| Issue Date : | 17 <sup>th</sup> November 2012 |  |
|--------------|--------------------------------|--|
| Product :    | Car2Go Head unit               |  |

**Hardware changes description**

### PV3 Hardware changes description/validation

Figure 1 Floating mating up to 1 mm

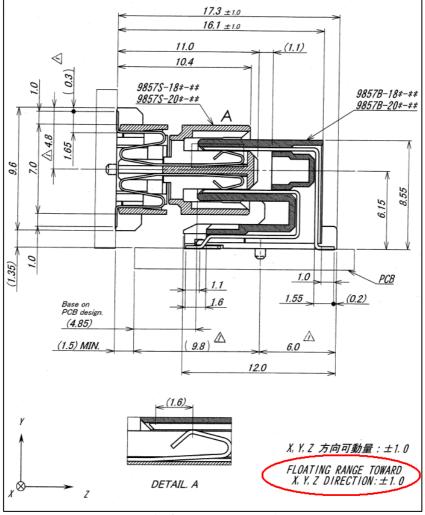
Kyocera connector (P/N 24\_5078\_050\_100\_861) has been replaced with Iriso (P/N 9857S-52A-GF) floating connector to prevent disconnection due to Z-axis vibration:

Figure 2 Crank line improvement for 2011 vehicles

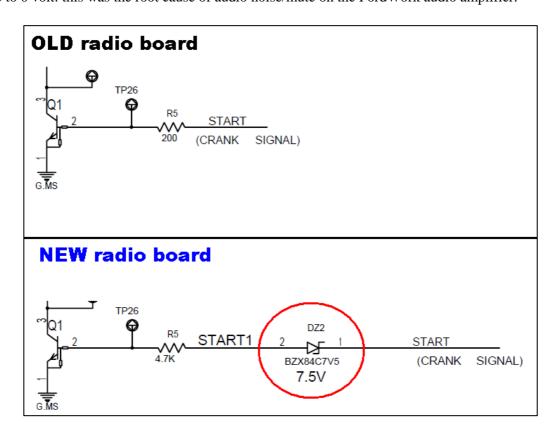
First release of radio board was not able to properly manage the START line signal of 2011 vehicles. This input was designed to properly manage an "off" state of START line close to 0 volt. Unfortunately on 2011 vehicle, the START line have a different behavior when not active, and the "off" state is no more close to 0 volt: this was the root cause of audio noise/mute on the FordWork audio amplifier.

On the new radio board a series Zener diode has been introduced to avoid unwanted "mute" of the audio amplifier due to different input voltage level on START line, while vehicle is not cranking.

Figure 3 External watch-dog functionality

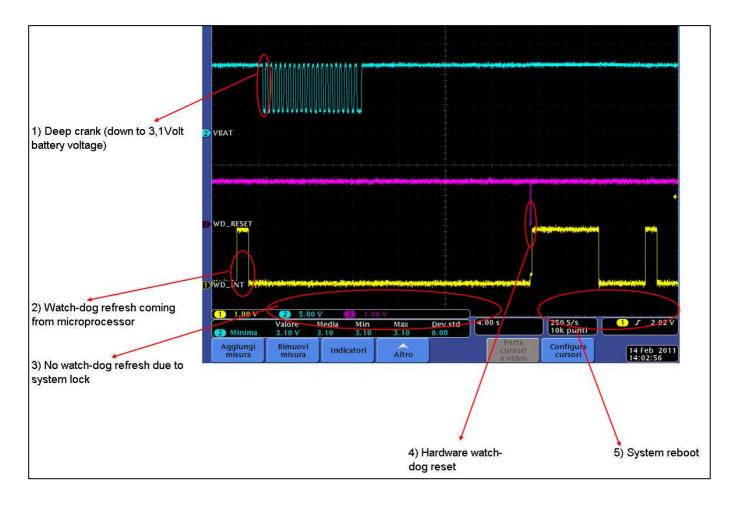
During low-battery crank, battery voltage can drop below 5 volt.

If this event happens on a PV1 system, the power mosfet who feed the microprocessor do not close completely and the core supply voltage can be out of range. This could generate a system hang-up with no system reset. The system do not boot again and stay permanently with the screen in dark mode.

- > a pull down resistor has been introduced on the interrupt pin of the system power supply IC (Daisy) to prevent from false boot condition due to leakage current
- > an external hardware watch-dog has been enabled to prevent from unwanted system hang up

In the picture above a deep-crank has been simulated (on the bench) to reproduce system hang-up and show the external watch dog intervention:

- 1. battery voltage (VBAT) falls repetitively down to 3,1 volt
- 2. the signal coming from the microprocessor to refresh the external watch-dog (WD\_INT) stops since the microprocessors hangs-up
- 3. the watch-dog internal counter elapses after about 25 seconds
- 4. a reset (WD\_RESET) is asserted from the watch-dog to the system
- 5. system reboot

Figure 4 CAN transceiver control comparison

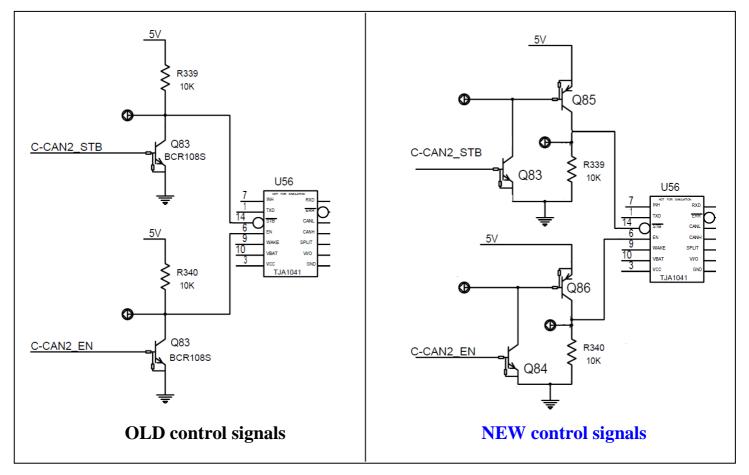
CAN transceiver control signals have been reversed on PRS3 as depicted in the picture below:

- ➤ old control: TJA1041 is active when C-CAN2\_STB and C-CAN2\_EN are low
- > new control: TJA1041 is active when C-CAN2\_STB and C-CAN2\_EN are high

In the old architecture, when system is booting (5Volt is high) C-CAN2\_STB and C-CAN2\_EN are low then EN and nSTB pin of TJA1041 are high: the transceiver is "on".

This mean that messages on the CAN bus go to the input of the microprocessor CAN cell, while it is booting.

Robust design rules require to properly initialize the CAN driver before receive any message from the CAN bus.

The improvement gained with the new control is that transceiver is "off" while system is booting because Q85 and Q86 are "off" then EN and nSTB pin are low also if 5Volt is high.

Figure 5 Additional motherboard locating hole

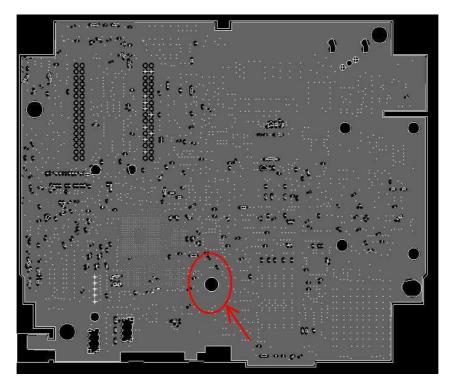
An additional hole has been introduced on (Lauberhorn C3 PRS4) mainboard to improve assembly/testing process reliability.

The additional hole do not have any impact on system performances hence do not need a specific test.
